SUNDRY NOTICES AND REPORTS ON WELLS (DO NOT USE THIS FORM FOR PROPOSALS TO DRILL OR TO DEEPEN OR PLUG BACK TO A DIFFERENT RESERVOIR. USE "APPLICATION FOR PERMIT" (FORM C-101) FOR SUCH PROPOSALS.)		WELL API NO. 30-015-31793

2. Name of Operator EOG RESOURCES INC		6. State Oil & Gas Lease No. V-3850
3. Address of Operator PO BOX 2267 MIDLAND, TX 79702		7. Lease Name or Unit Agreement Name LUCY ALC STATE

Lucy ALC State #3 – P&A

Proposed Wellbore Diagram:

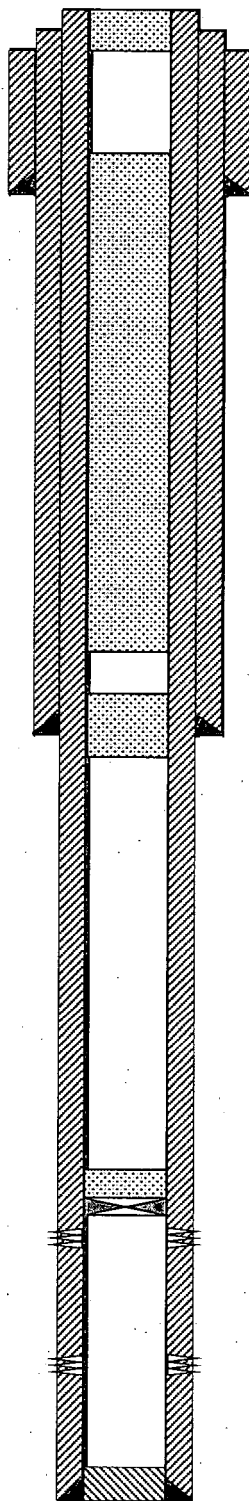
Run CBL to Verify Cement Top
